RESOLUTION NO. 352

**A RESOLUTION OF THE CITY OF SHORELINE, WASHINGTON AMENDING THE TRANSPORTATION MASTER PLAN TO RECLASSIFY A COLLECTOR ARTERIAL TO A LOCAL SECONDARY STREET, REVISE A CROSS-SECTION, PROVIDE CLARIFYING NOTES TO THE MASTER STREET PLAN, AND CORRECT SCRIVENER'S ERRORS RELATED TO RIGHT-OF-WAY AND THE STREET CLASSIFICATION MAP**

**EXHIBIT A – RECOMMENDED CHANGES TO THE TRANSPORTATION MASTER PLAN**

APPENDIX D

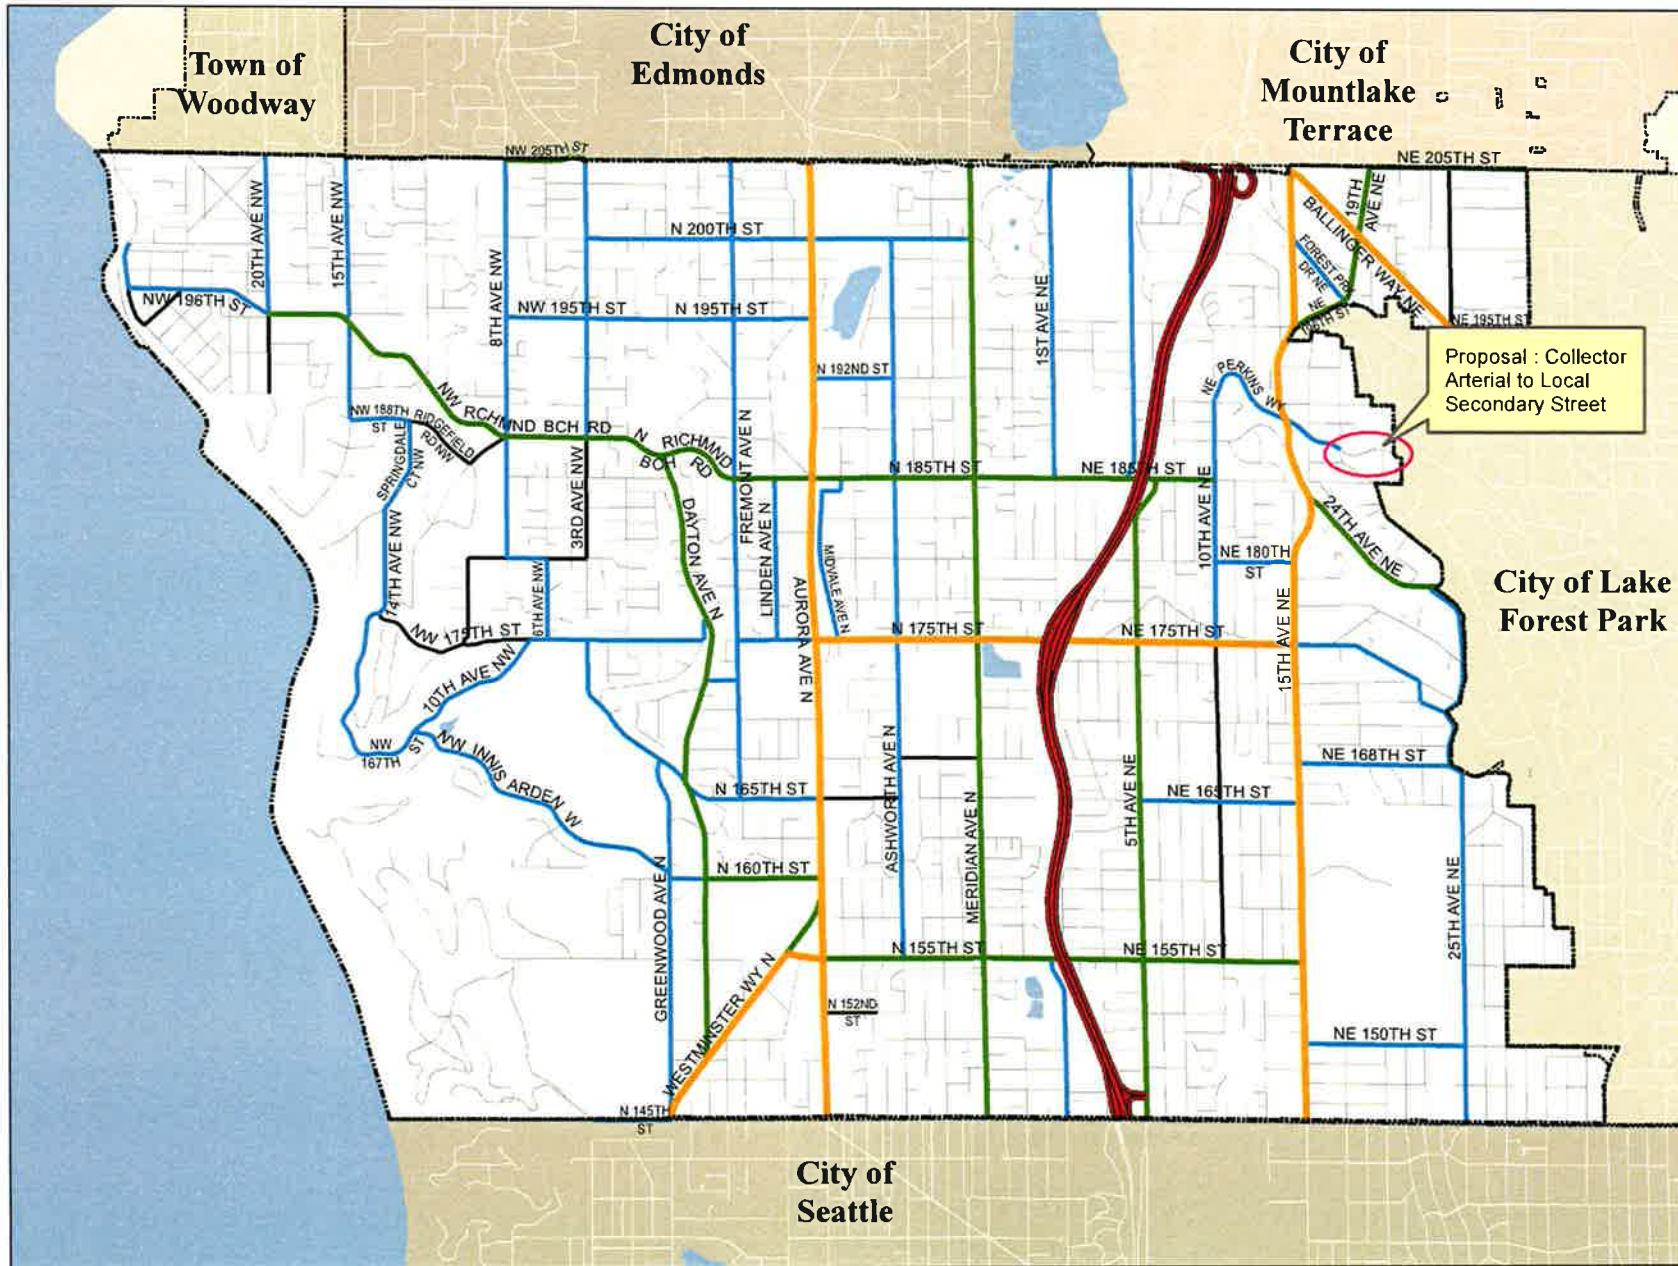
2	Appendix D	Master Street Plan	See below	<ul style="list-style-type: none"> <li>Correcting the right-of-way width for 5<sup>th</sup> Avenue NE from NE 185<sup>th</sup> Street to NE 195<sup>th</sup> Street, as the existing MSP identifies an incorrect requirement.</li> <li>Correcting the notes associated with the roadway segment on 10<sup>th</sup> Avenue NE from NE 175<sup>th</sup> Street to NE 185<sup>th</sup> Street. During the planning for the City’s North Fork Thornton Creek Low Impact Development (LID) Stormwater Retrofit Project, staff found that space could be utilized behind the sidewalks on both the east and west sides of the roadway and is recommending removal of the language that specifies this allowance for the west side only.</li> <li>Include the width requirements for sidewalks associated with adjacent land uses on Local Secondary Streets. This requirement is already stated within the text of the TMP.</li> <li>Change the cross-section of the segment of Westminster Way N from Greenwood Avenue N to Fremont Avenue N to match that of the segment from Fremont Avenue N to N 155<sup>th</sup> Street. Due to the potential redevelopment of Aurora Square as part of the Community Redevelopment Plan, the City should maintain a wider cross-section until such time as the roadway needs can be studied.</li> <li>Correct the termini of NE Perkins Way as a Collector Arterial at 18<sup>th</sup> Avenue NE in accordance with WSDOT’s determination</li> </ul>

FUNCTIONAL CLASSIFICATION	STREET NAME	FROM	TO	TOTAL EXISTING RIGHT-OF-WAY	EXISTING CURB TO CURB WIDTH	REQUIRED RIGHT-OF-WAY	PLANNED CURB TO CURB WIDTH	NOTES
Collector Arterial	5 <sup>th</sup> Ave NE	NE 185 <sup>th</sup> St	NE 195 <sup>th</sup> St	30-116	16-28	<del>70</del> 66	38	
Collector Arterial	10 <sup>th</sup> Ave NE	NE 175 <sup>th</sup> St	NE 185 <sup>th</sup> St	70-80	32	70-80	38	Utilize the space behind the west sidewalk for natural stormwater management
Collector Arterial	25 <sup>th</sup> Ave NE	NE 177 <sup>th</sup> St	NE 178 <sup>th</sup> St	60-110	27	<del>50</del> 45	24	Amenity zone will be the shoulder. Preferred width on the east. <u>No sidewalk is planned for the west side of the street due to topography and surface water management needs.</u>
Principal Arterial	Westminster Way N	Greenwood Ave N	Fremont Ave N	90	60-64	68	44	<del>Two travel lanes in each direction</del>
Collector Arterial	NE Perkins Way	15 <sup>th</sup> Ave NE	City limits 18 <sup>th</sup> Ave NE	60	25-41	60	38

Principal Arterial	Westminster Way N	Fremont Ave N Greenwood Ave N	N 155 <sup>th</sup> St	90-125	60-78	90	60	Two travel lanes in each direction. <u>Study needed to determine appropriate cross-section in response to redevelopment at Aurora Square.</u>
Local Secondary Street	Generic Cross Section			Varies	Varies	60	32	<u>Five feet is the standard sidewalk width adjacent to single family residential land uses and eight feet is the standard sidewalk width adjacent to all land uses other than single-family residential. Increased width may be required if determined by a traffic study.</u>
